From: HUBBARD, BRADLEY <bhubbard@usbr.gov>
Sent: Thursday, October 23, 2014 5:00 PM
To: Buckman, Carolyn; Veronese, Gina; Frances Mizuno
Subject: Fwd: Question regarding Long-Term Water Transfers Draft EIS-EIR

Re: Comments on the Long-Term Water Transfers Draft Environmental Impact Statement / Environmental Impact Report

Figure 1. Normalized Stream Depletion Curve. (from TNC 2014, normalized to the simulated amount pumped in one season.)

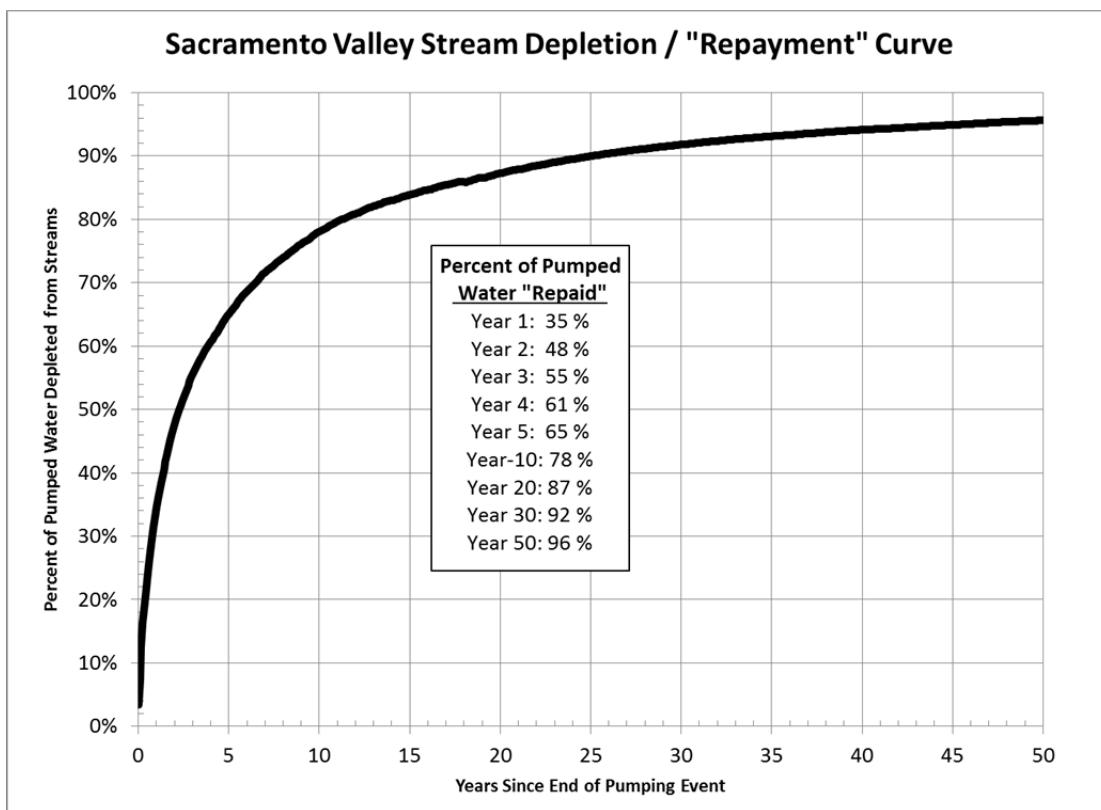
Simulations performed by TNC using DWR's C2VSim integrated ground and surface water model of the Central Valley indicate that groundwater pumping at scales similar to the Proposed Action affects a large area and, very importantly, that streamflow depletion from even a single year of such pumping persists for decades⁷. The timing of these impacts is illustrated in Figure 1, below.

Figure 1 shows that streamflow depletion is significant for many years after pumping has ceased, with only about 65 percent of ultimate stream depletion expressed even 5 years after pumping has stopped. It takes 25 years for the system to nearly fully "recover" (90 percent "depletion recovery"). Although different assumptions regarding well locations and depth will lead to differently shaped depletion curves, the best information available suggests that impacts from pumping will persist for decades for wells distributed over wide areas and depths, as is the case for the Proposed Action. In contrast, Figure 3.1-3 of the EIS/EIR does not reflect this full duration of impact, at least as expressed in percent changes in CVP and SWP exports. Please explain how the modeling done for this Draft EIS/EIR accounts for the compounding impacts to water supplies from multiple years of pumping, and how the duration of impact through full recovery will be accounted and mitigated under Mitigation Measure WS-1.

To appropriately characterize the potential water supply and environmental impacts of the Proposed Action, the Draft EIS/EIR must more clearly answer the question, “Which streams are likely to be depleted, by how much, and for how long?” The EIS/EIR needs to better account for the source of pumped water and its related cumulative impacts over time to both water rights holders (both export rights and in-valley rights) and the environment, and avoid or fully mitigate for those impacts. To fully mitigate for groundwater substitution pumping impacts on water supplies, Section 3.1.4.1, *Mitigation Measure WS-1*, must describe in detail how the streamflow depletion factor will be developed, account for compounding, and be applied over the duration of the project and beyond until recovery is achieved.
